# Appendix A: Responses to expert's letter dated 22nd November 2024

## Summary of responses

This PDF document shows Beca replies (in blue) to the letter prepared by Mr Lines and Dr Hargraves dated 22nd November 2024. These responses should be read in conjunction with the text in the Statement of Reply of Dan Chamberose (27 November 2024) document under Section 5. SLOPE INSTABILITY SUSCEPTIBILITY OVERLAYS AND DEBRIS RUN-OUT OVERLAY – ACCURACY OF THE OVERLAYS.

Figure A 14 - Suffolk Heights

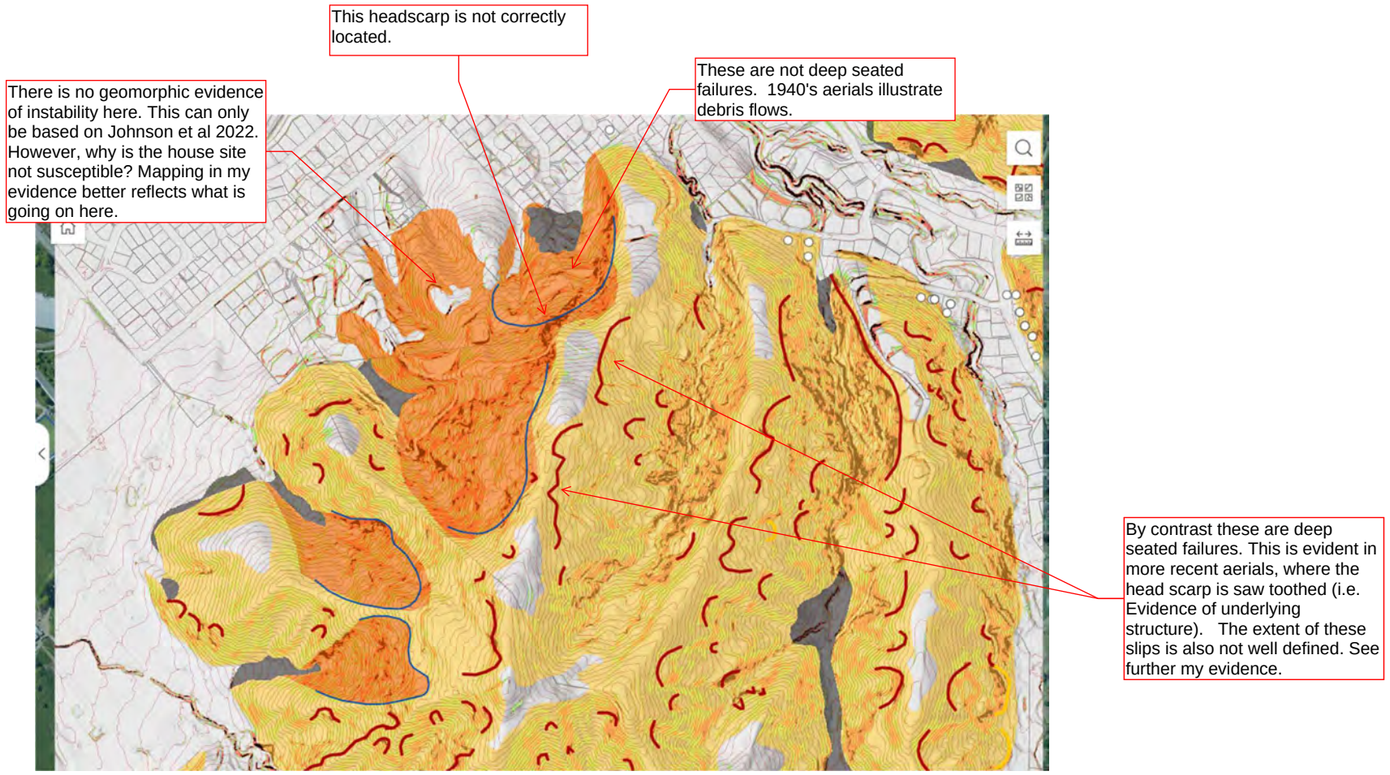
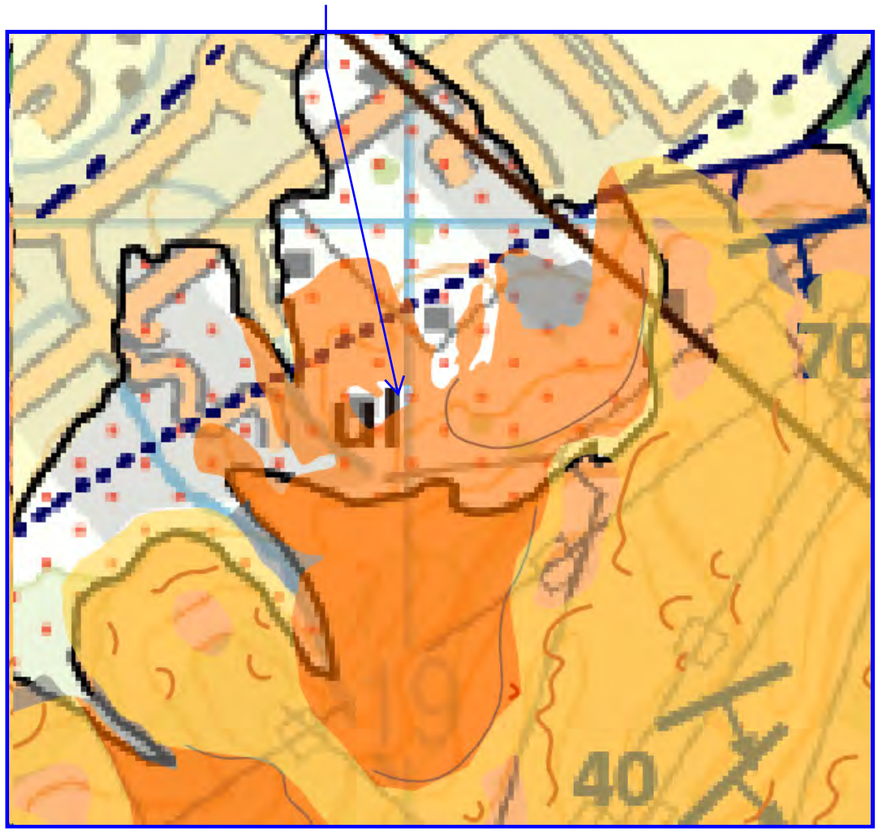
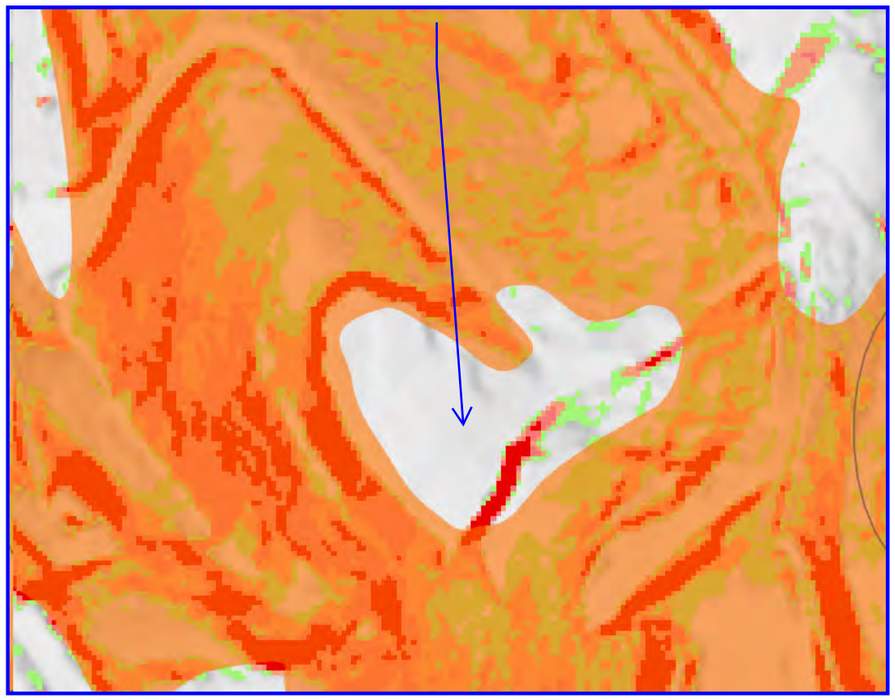
| A13 + A14 | Suffolk Heights | The headscarp of one deep seated failure shown in the Beca inventory does not directly correspond to the boundaries of Tier II and associated geomorphic evidence visible in the DEM and there is no mapped evidence for instability in the lower portion of the Tier II in the Beca inventory. Features are noted as being debris flows not deep-seated slope failures (both warrant Tier II). Additional deep-seated features are identified on the adjacent hillslope that are shown as shallow failures in the Beca inventory (Area is within Tier III). | Tier 2: These areas are mapped as landslide deposits in the Johnston et al. 2021 map and their extents were refined based on interpretation of the DEM, therefore, the areas were included as Tier 2. The scarp location was defined as presented in the overlay extents during the review process ,but not updated in the inventory. The 'hole' in tier 2 identified at Suffolk Heights is there because of the way the maps were developed and is a hangover of this. The original slope overlay maps were one map without any Tiers identified and was largely developed by the 20 degree slope angle/geomorph evidence criteria of the methodology tree. Based on the recommendation from the SI-TAG, the map was split out into the different tiers, but its extents were not changed. As this area was less than the 20 degrees criteria in the original overlay it was not included. When the map was differentiated into its tiers, the map extents were not changed therefore it was not included in the updated overlay with the tiers.<br><br>Tier 3: Based on the datasets used/available to the assessing person (and verifier), they assessed and made judgement that the feature was either shallow or deep because the way they interpreted the datasets/information. To make a decision on whether an area fell within Area 2 or Area 3 of the slope overlay, they needed confidence or possibly additional information that was not available to them to decide, therefore made an appropriate judgement with the information at hand. To confirm if it was deeper seated would require field verification, intrusive investigations or site-specific knowledge which was not included or available as part of developing regional scale susceptibility maps in this area.<br><br>Note: if the recommendation to combine areas 2 and 3 is accepted, then the extents of the overlay will not change in this area. Also, some of this area is outside of PC29 extents. | No overlay update required |

Tier 2: These areas are mapped as landslide deposits in the Johnston et al. 2021 map and their extents were refined based on interpretation of the DEM, therefore, the areas were included as Tier 2. The scarp location was defined as presented in the overlay extents during the review process ,but not updated in the inventory. The 'hole' in tier 2 identified at Suffolk Heights is there because of the way the maps were developed and is a hangover of this. The original slope overlay maps were one map without any Tiers identified and was largely developed by the 20 degree slope angle/geomorph evidence criteria of the methodology tree. Based on the recommendation from the SI-TAG, the map was split out into the different tiers, but its extents were not changed. As this area was less than the 20 degrees criteria in the original overlay it was not included. When the map was differentiated into its tiers, the map extents were not changed therefore it was not included in the updated overlay with the tiers.

Tier 3: Based on the datasets used/available to the assessing person (and verifier), they assessed and made judgement that the feature was either shallow or deep because the way they interpreted the datasets/information. To make a decision on whether an area fell within Area 2 or Area 3 of the slope overlay, they needed confidence or possibly additional information that was not available to them to decide, therefore made an appropriate judgement with the information at hand. To confirm if it was deeper seated would require field verification, intrusive investigations or site specific knowledge which was not included or available as part of developing regional scale susceptibility maps in this area.

Note: if the recommendation to combine areas 2 and 3 is accepted, then the extents of the overlay will not change in this area. Also, some of this area is outside of PC29 extents.

Mapped as landslide deposits in Johnston et al. 2021

Area <20 degrees therefore did not meet slope angle criteria to be included in original overlay

Figure A 15 - Quail Rise to Marsden Valley Road

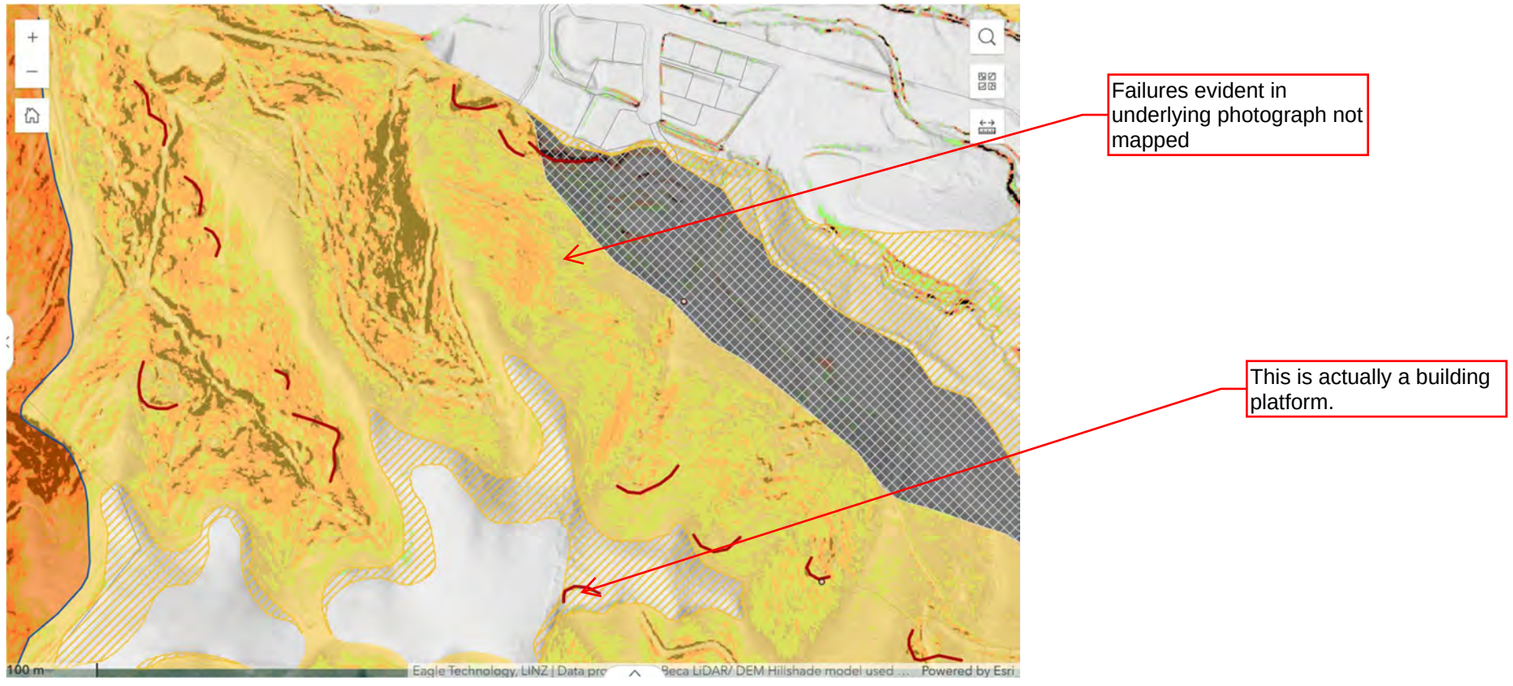
| A15 | Quail Rise to Marsden Valley Road | Specific evidence of slope instability (headscarps) visible in the DEM are not present in Beca inventory on a slope within Tier III and mapped on the wider hillslope. One feature within the inventory is identified as relating to a building platform, not slope failure. | The slope instability inventory has been created in accordance with the AGS guidance and aligns with a 'basic' level inventory. The mapping of features is not considered to be an exhaustive record of all instability in the region but is sufficient to show the classification and distribution of slope instability on hillslopes in the region. The aim of the mapping was to capture a representation of slope failure locations and types in the region. In my opinion, this type of inventory, in combination with the other evidence of slope instability (i.e. records provided by NCC and the Post-August 2022 landslide dataset provided by GNS) is sufficient to inform the creation of these slope overlays and aligns with the AGS guidance. | No overlay update required |

The slope instability inventory has been created in accordance with the AGS guidance and aligns with a ‘basic’ level inventory. The mapping of features is not considered to be an exhaustive record of all instability in the region but is sufficient to show the classification and distribution of slope instability on hillslopes in the region. The aim of the mapping was to capture a representation of slope failure locations and types in the region. In my opinion, this type of inventory, in combination with the other evidence of slope instability (i.e. records provided by NCC and the Post-August 2022 landslide dataset provided by GNS) is sufficient to inform the creation of these slope overlays and aligns with the AGS guidance.

Features/areas identified by the experts are within the extents of the overlay, therefore no change is required.

Figure A-16 Woodford / Sunningdale Drive

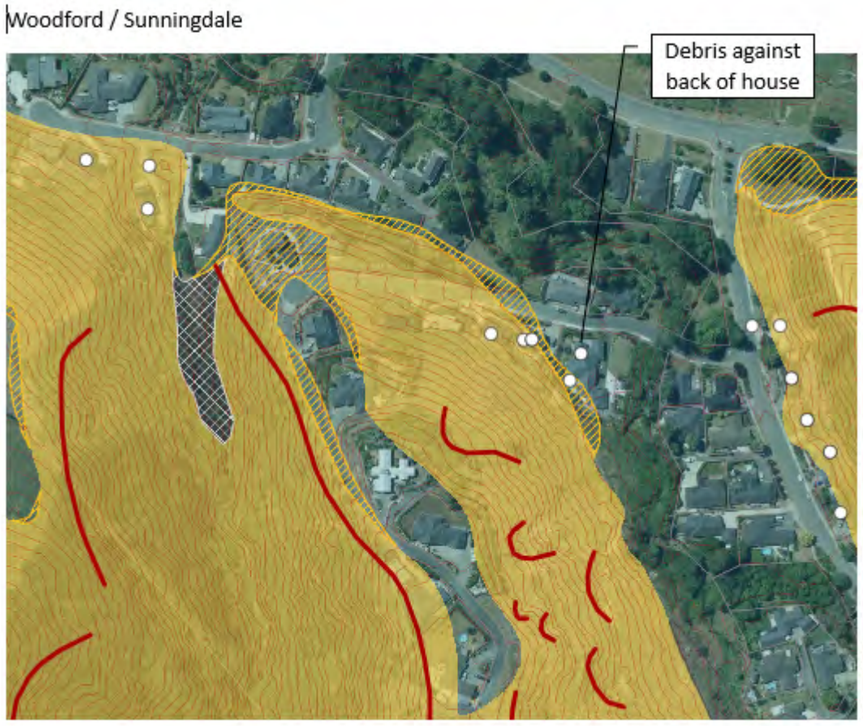
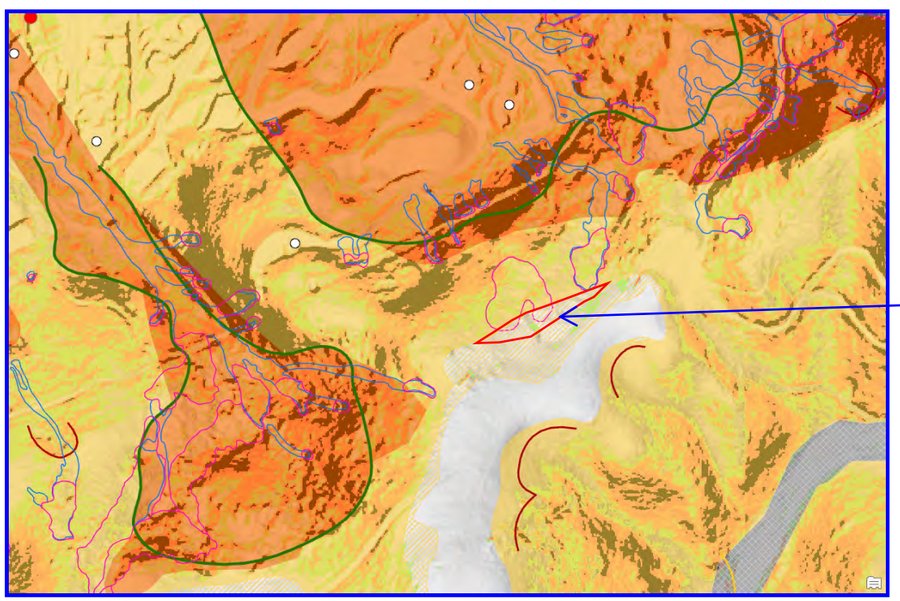
| A16 | Woodford / Sunningdale Drive | Evidence of debris inundating the rear of a house during the August 2022 event is noted by a white dot in an area outside of the Tier III and runout overlays. | I agree that this area should be included in the slope overlay (see snip) | Update Tier III boundary to incorporate area at rear of property that was inundated with debris. Revised area is not outside the original Beca (2023) overlay extents |

I agree that this area should be included in the slope overlay (see snip)

Proposed extent of addition to overlay. Area is not outside the notified PC29 overlay extents

Figure A-17 Atawhai

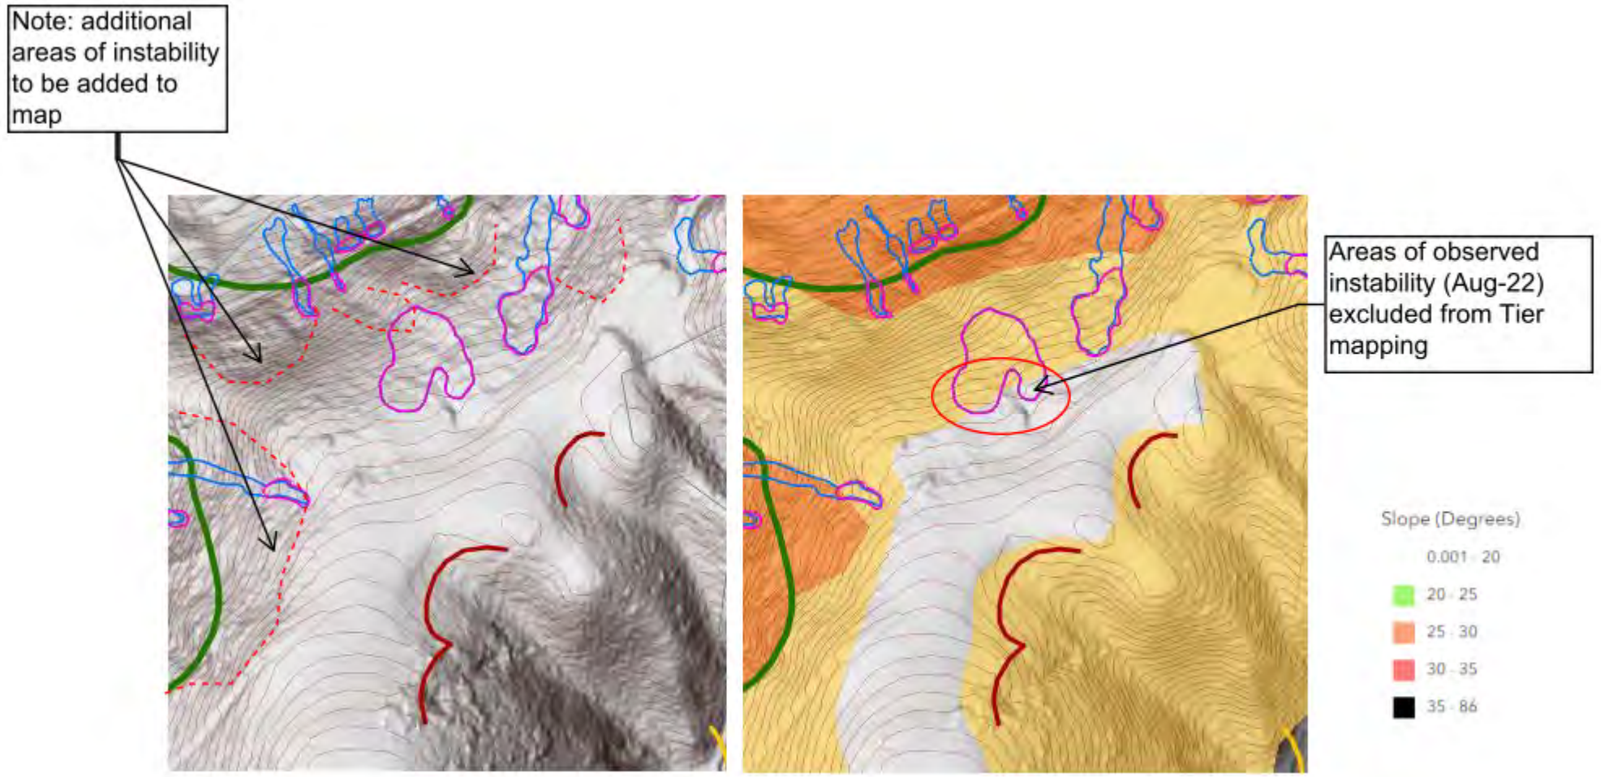
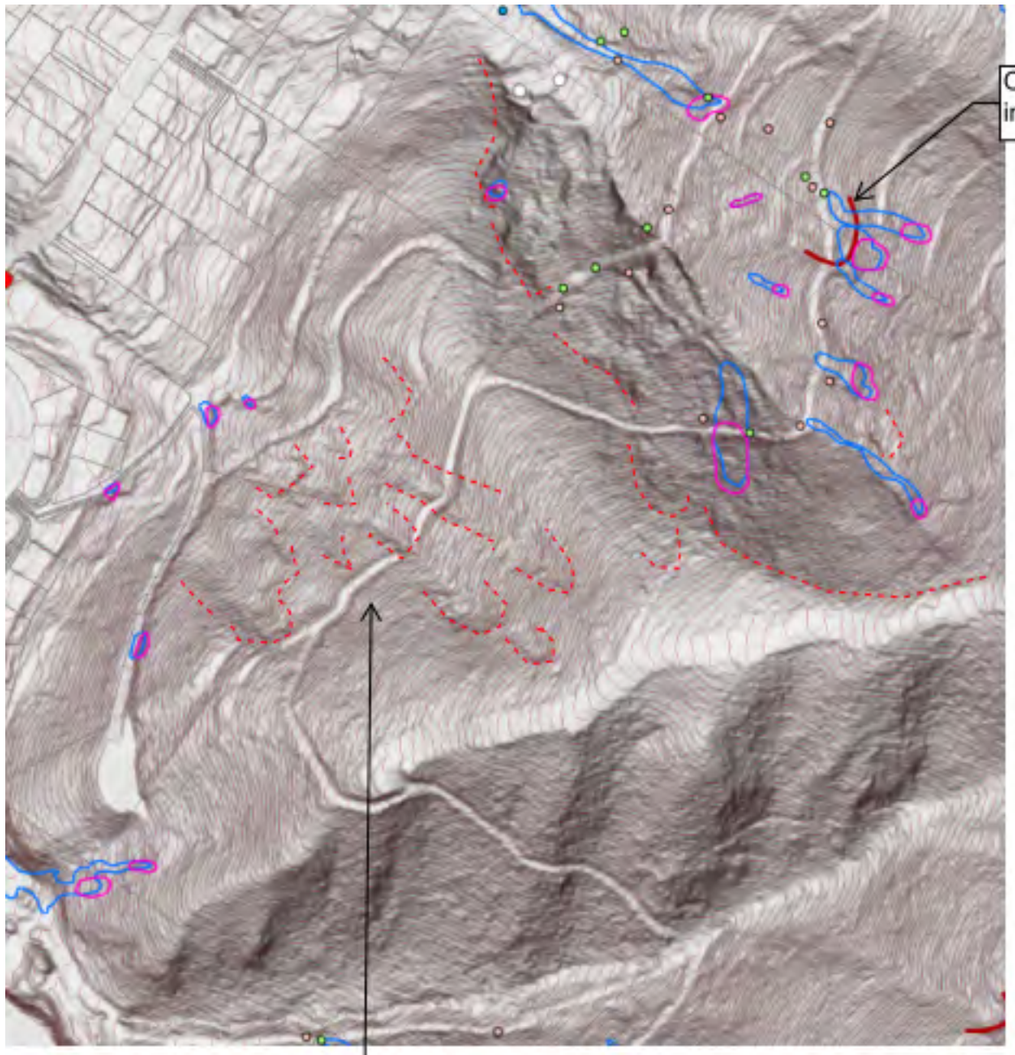
This snip shows how very basic the Beca georphological mapping was and how many obvious landslip features are missing. Instead of just mapping landslip scarps, Beca might also have considered mapping whole areas as either being subject to shallow or deep-seated instability.

I agree that this small area should be included in the overlay (see snip in PDF for proposed extents)

With respect to other areas of instability noted. The slope instability inventory has been created in accordance with the AGS guidance and aligns with a ‘basic’ level inventory. The mapping of features is not considered to be an exhaustive record of all instability in the region but is sufficient to show the classification and distribution of slope instability on hillslopes in the region. The aim of the mapping was to capture a representation of slope failure locations and types in the region. In my opinion, this type of inventory, in combination with the other evidence of slope instability (i.e. records provided by NCC and the Post-August 2022 landslide dataset provided by GNS) is sufficient to inform the creation of these slope overlays and aligns with the AGS guidance. This does not affect the extent of the overlays, therefore no change is required for these.

Distance = 8m; note scale of mapping. This was snipped at 1:5000

Proposed extent of addition to overlay. Area is not outside the notified PC29 overlay extents
